UNITED STATES PATENT AND TRADEMARK OFFICE

10/588,936

Office Action Summary	Application No.	Applicant(s)	
	10/588,936	TABATA ET AL.	
	Examiner	Art Unit	
	Lucas Stelling	1776

DETAILED ACTION

FIG. 12

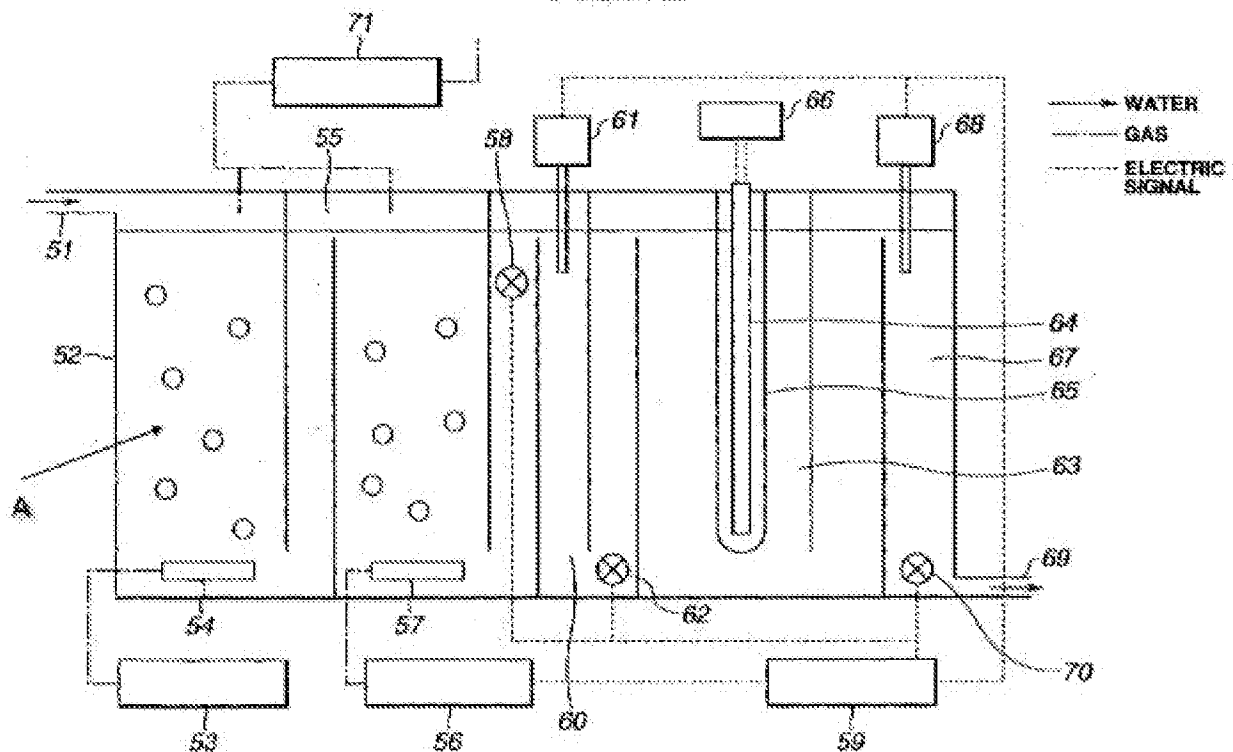
a wastewater treatment bath for treating wastewater **(See Noguchi Fig. 12, and edited Fig. 12 below, 'A' represents the treatment bath into which ozone is provided through 54 see also [0046])**;

an oxidizing reagent adding unit for adding an oxidizing reagent in the wastewater treatment bath **(54 and see [0046])**, a pH of the wastewater treatment bath being within a range from 7-12 based upon an alkaline reagent;

an ultraviolet treatment unit **(63 is a photocatalytic reaction vessel, having an ultraviolet lamp 64)** for irradiating an ultraviolet ray comprising:

a reaction bath that receives the oxidized water fed from wastewater treatment bath **(63)**; and

an ultraviolet lamp **(64)** that irradiates an ultraviolet ray towards the oxidized water in the reaction; and

an acid treatment bath **(60)** having an acid adding unit **(61)** for adding acid, the acid treatment bath provided on a downstream side of the wastewater treatment bath and on an upstream side of the ultraviolet treatment unit **(See Noguchi Fig. 12 and see edited Fig. 12 below)**.

Noguchi is different from claim 19, in that Noguchi does not teach a pump which feeds oxidized water from the wastewater treatment bath to the ultraviolet treatment unit reaction bath, or that the UV lamp is provided above the reaction bath.

It is acknowledged that the embodiment of Fig. 12 in Noguchi does not mention removing persistence substances such as COD components contained in a wastewater produced and discharged in a gas purification process of a gasification facility; that the acid treatment bath has a pH of 2-4, that the wastewater treatment bath has a pH of 7-12, or that the UV lamp decomposes COD components. However these limitations are drawn to applicant's intended use of the system and they do not serve to define it in terms of its structure. See MPEP 2114 and 2115. Noguchi is fully capable of meeting these limitations. Such a discharged liquid could be provided to the apparatus. The solution pH in the acid treatment bath can be made to between 2 and 4 with the acid adding unit, a pH adjusted water can be supplied to the inlet of the device thereby providing a pH in the wastewater treatment bath of between 7-12, and the UV light facilitates oxidation reactions which will reduce COD.

14. As to claim 31, Noguchi teaches a wastewater treatment apparatus comprising:
a wastewater treatment bath for treating the wastewater **(See Noguchi Fig. 12, and edited Fig. 12 below, 'A' represents the treatment bath into which ozone is provided through 54 see also [0046])**;

an ultraviolet lamp **(64)** that irradiates an ultraviolet ray toward the oxidized water in the reaction bath **(See Fig. 12, since 64 is placed inside 63 it will necessarily direct UV rays towards the water in the bath)**; and an acid treatment bath **(60)** having an acid adding unit **(61)** for adding acid, the acid treatment bath provided on a downstream side of the wastewater treatment bath and on an upstream side of the ultraviolet treatment unit **(See Noguchi Fig. 12 and see edited Fig. 12 above)**.
